Three Mile Island Nuclear Station Unit No. 1
Docket Number 50-289

Errata Sheet to responses to questions raised in Enclosure 2
of the NRC's 2-18-76 letter to TMI-1 concerning Appendix I

RESPONSES TO QUESTIONS RAISED IN ENCLOSURE 2

CONCERNING APPENDIX I

FIGURE 8-11
THREE MILE ISLAND UNITS 1 & 2

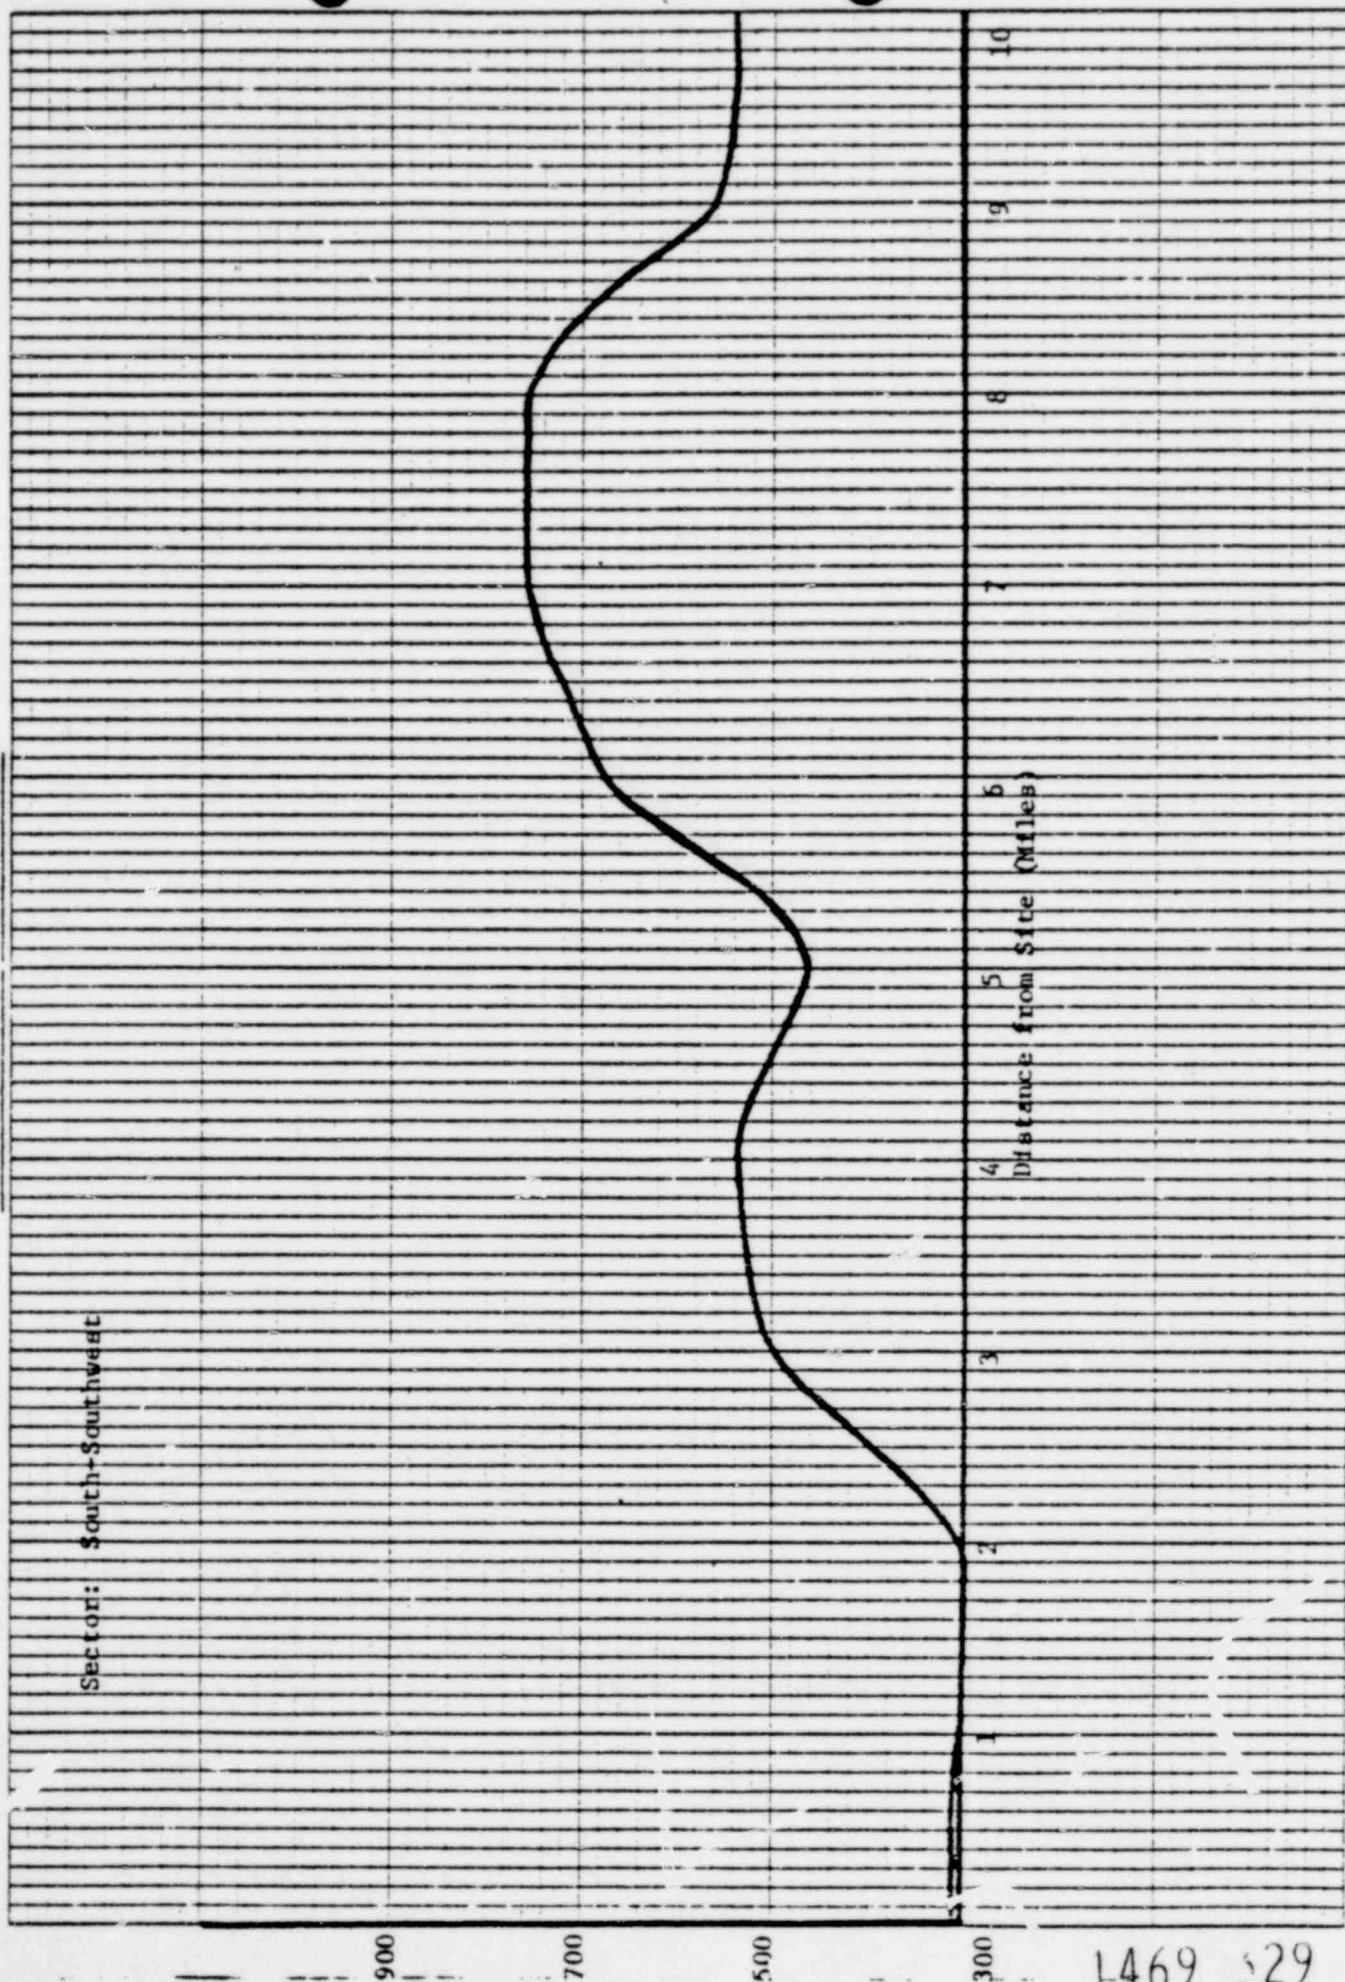
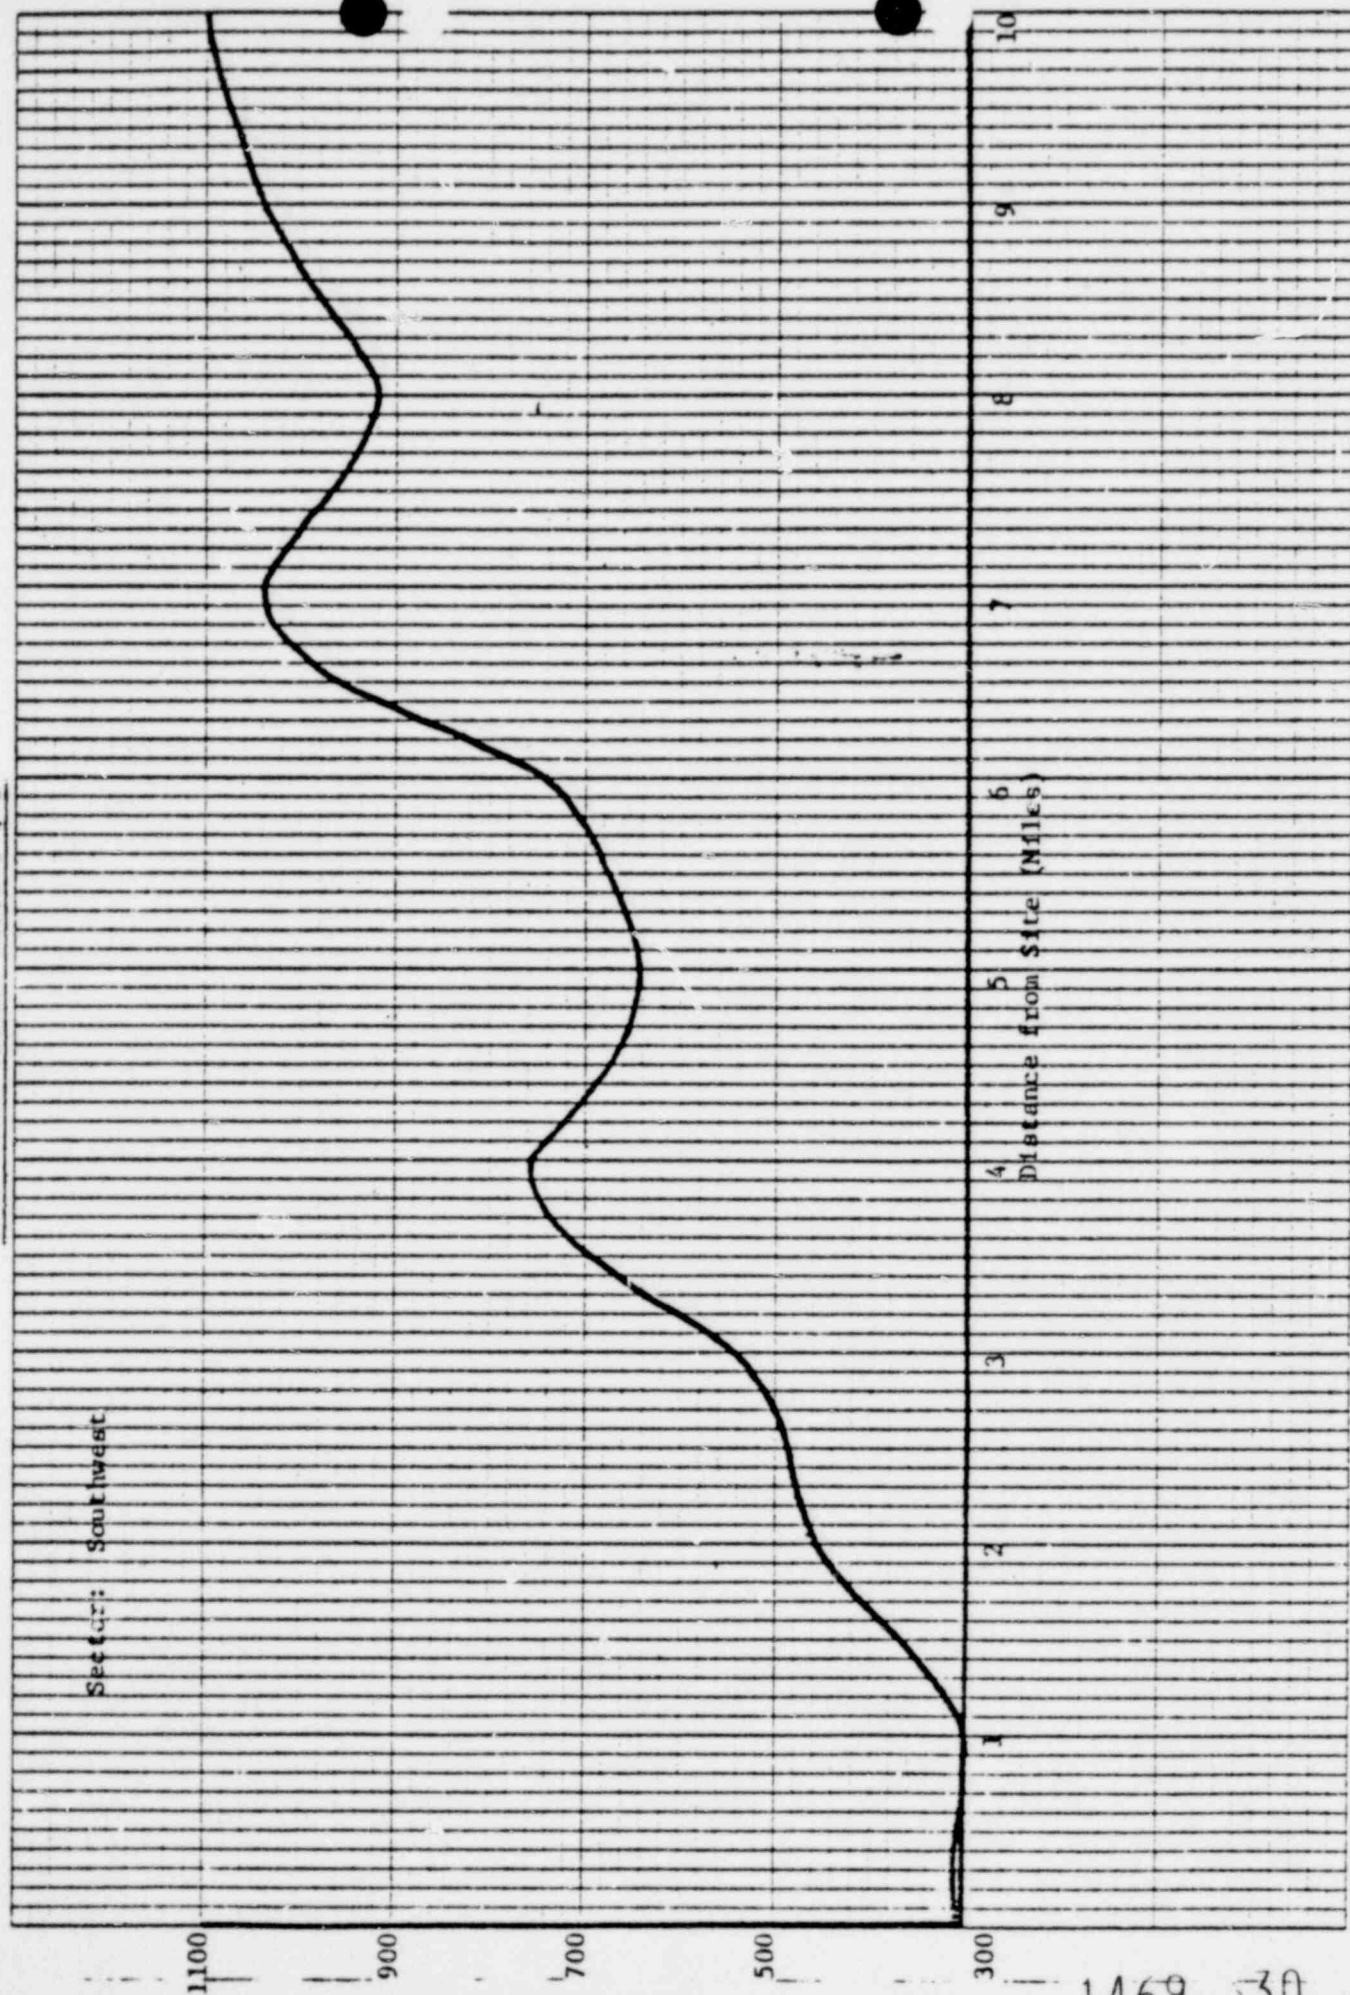
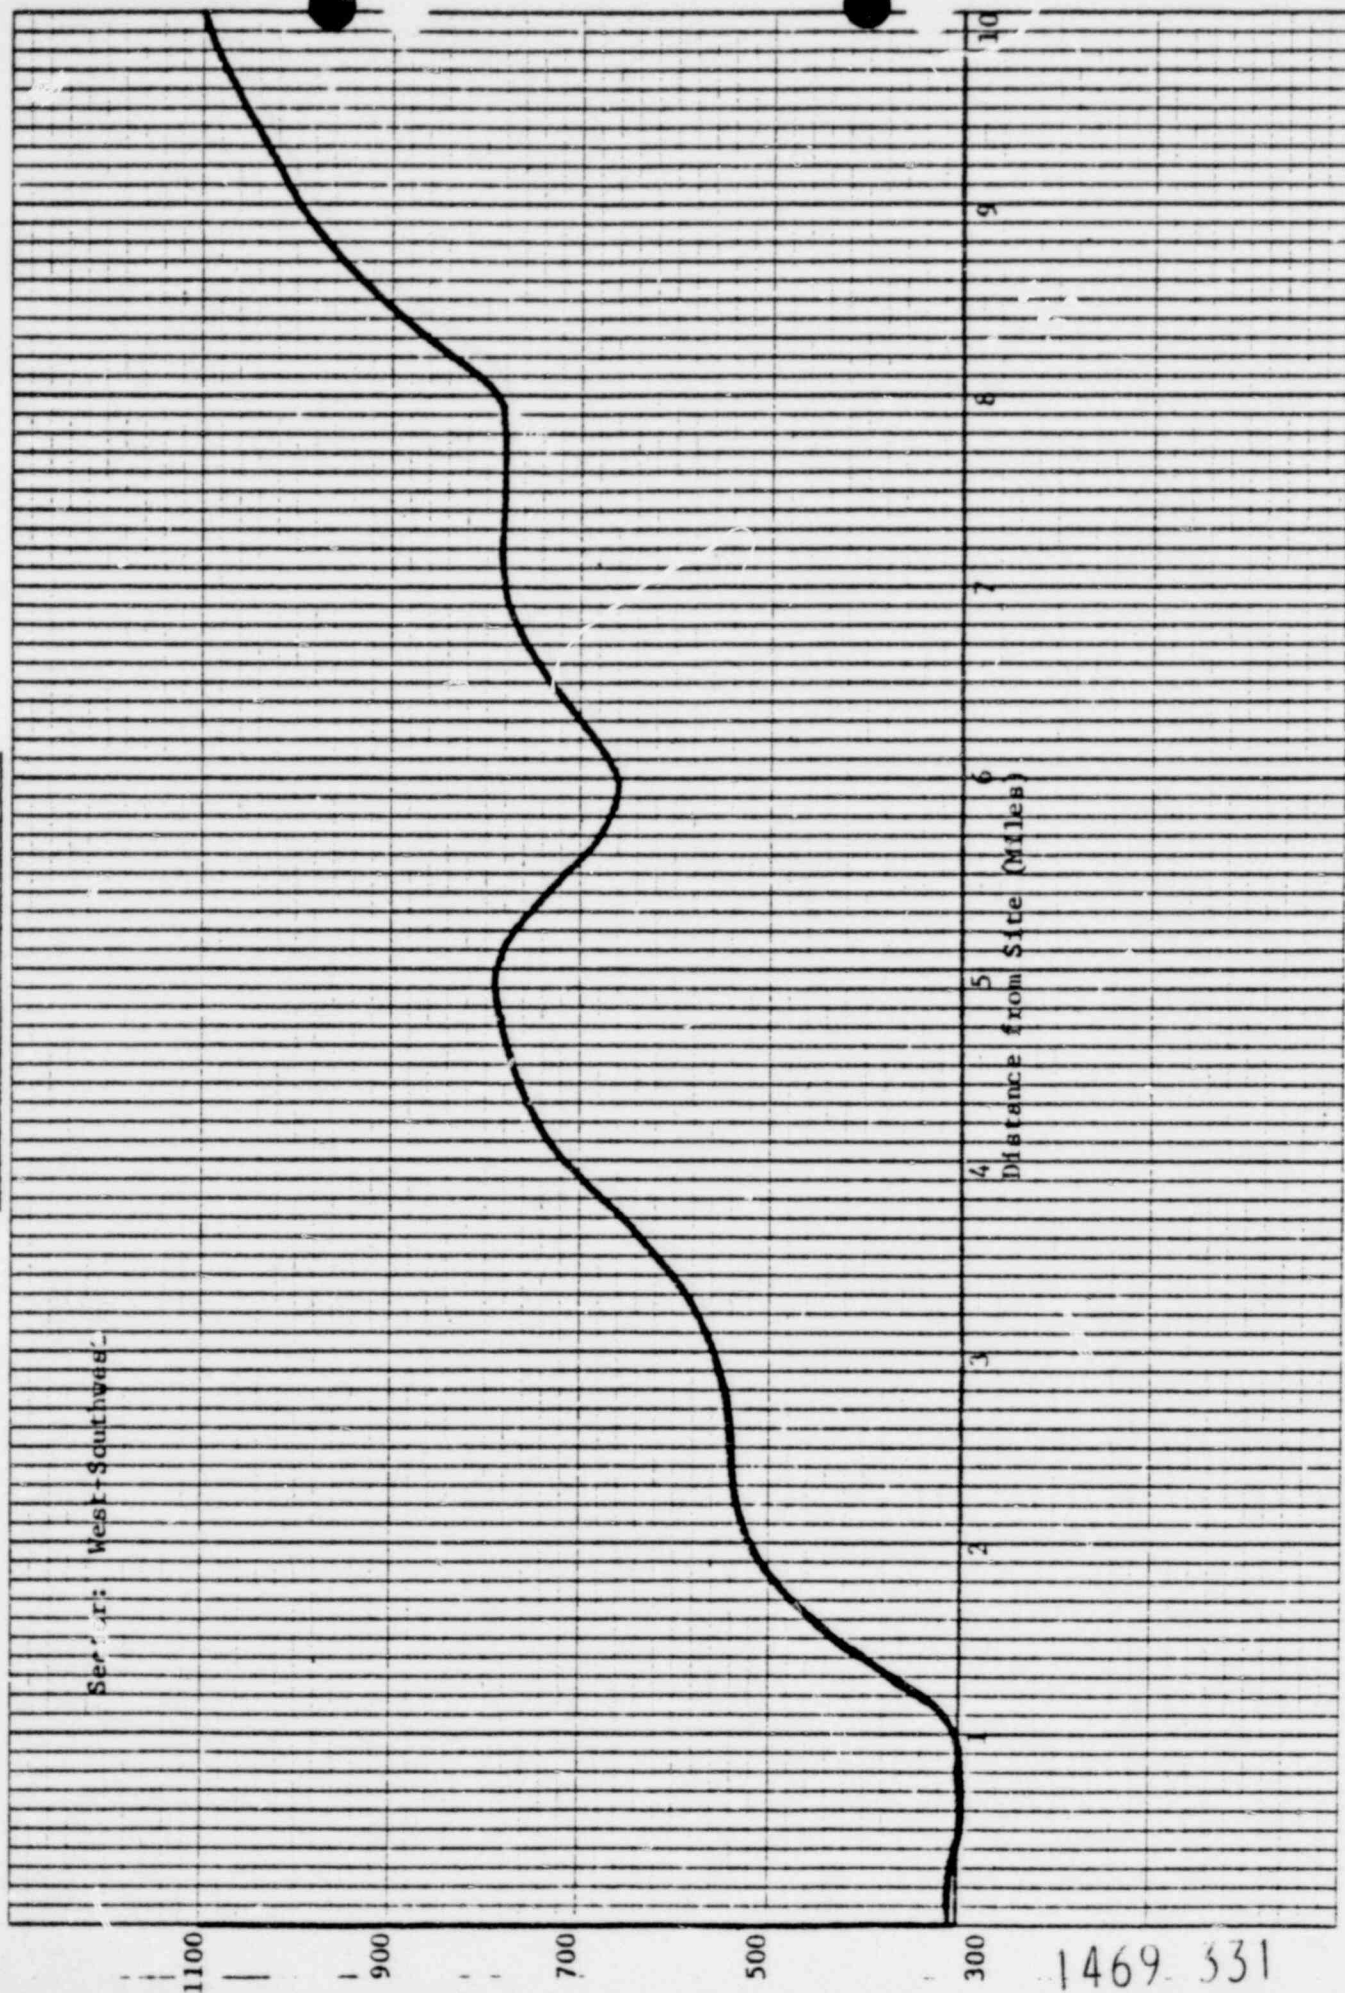
Provide a map showing the detailed topographical features (as modified by the plant) on a large scale, within a 10-mile radius of the plant and a plot of the maximum topographic elevation versus distance from the center of the plant in each of the sixteen 22-1/2 degree cardinal compass point sectors (centered on true north), radiating from the center of the plant, to a distance of 10 miles.

RESPONSE

See attached Table 8-1 and Figures 8-1 through 8-16.
